SITE PLAN REVISIONS

SPECIAL PERMIT PLAN OF THE RESIDENCES AT PAWTUCKETVILLE IN LOWELL, MA

PREPARED FOR GPG VARNUM, LLC

DATE: OCTOBER 29, 2015
REV.: OCTOBER 13, 2016

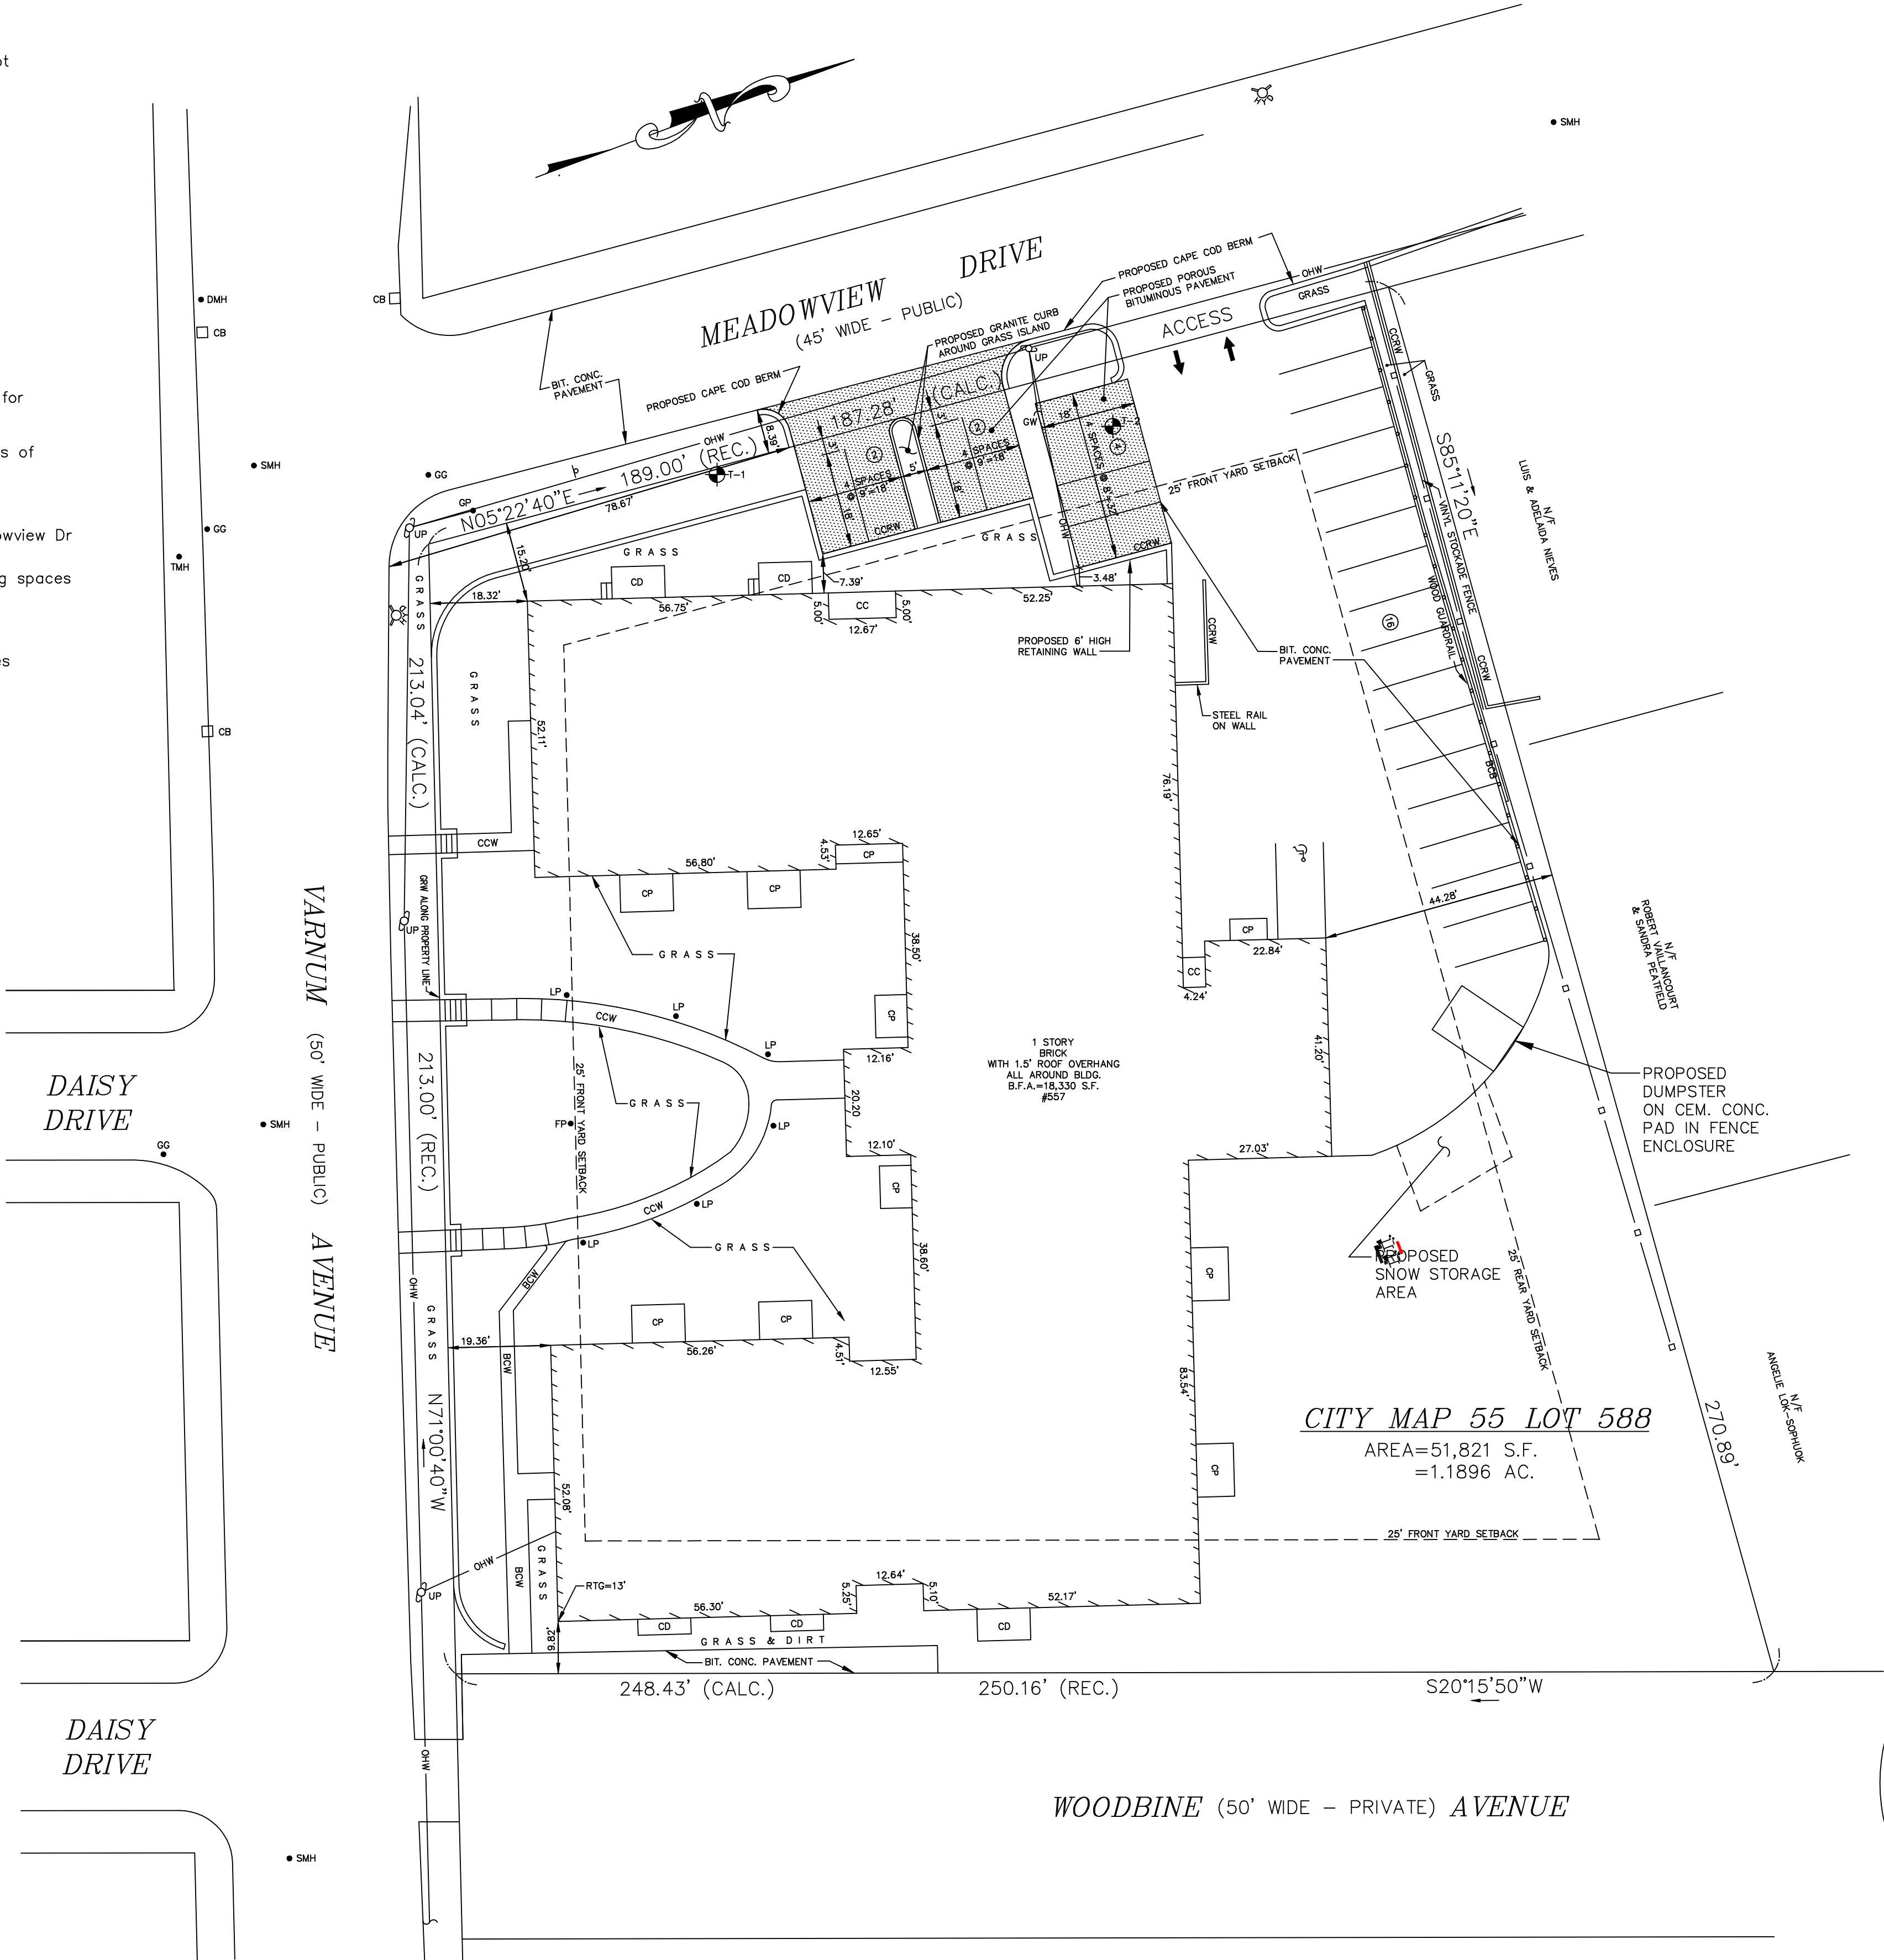
- Deleted the 1-Story Steel structure at the rear of the building
- Deleted both sheds at the rear of the building
- Deleted the southerly handicap parking space at the rear of the building and added a handicap parking space to the easterly parking lot

- Replaced the steel guardrail in the rear parking lot and replaced it with a longer wooden guard rail
- Added a stockade fence to the northerly property line

- Deleted the first parking space in the rear parking lot that's partially located in the street (Meadowview Dr) and updated the rear parking lot count to 16, not including the 1 handicap reserved space

- Added a landscaped island to the northwest corner of the site
- Deleted the first space on each side of the easterly parking lot and updated the parking counts appropriately

- Deleted all AC units from around the perimeter of the building
- Deleted the canvass awning from the Varnum Ave entrance
- Deleted the "Sign" on the front lawn (Varnum Ave side)

- Deleted the CC ramp at the rear of the building (near the proposed dumpster location)
- Added concrete patios and composite decks to building perimeter

- Deleted the two platforms and stairs in front of the exit/entry doors for each wing (Varnum Ave side of bldg)
- Added new retaining walls to the Varnum Ave and Meadowview Dr sides of the site.

- Deleted wrought aluminum fence along Varnum Ave
- Deleted parking lot on Woodbine Ave and removed generator on Meadowview Dr (9/13/16).
- Revised proposed retaining wall location and added 11 proposed parking spaces along Meadowview Dr. (9/13/16).

- Revised proposed 8 parking spaces along Meadowview Dr. (9/27/16)
- Revised proposed retaining wall location and proposed 4 parking spaces along Meadowview Dr. (9/30/16).

- Add proposed cap cod berm along Meadowview Dr. (10/13/16).
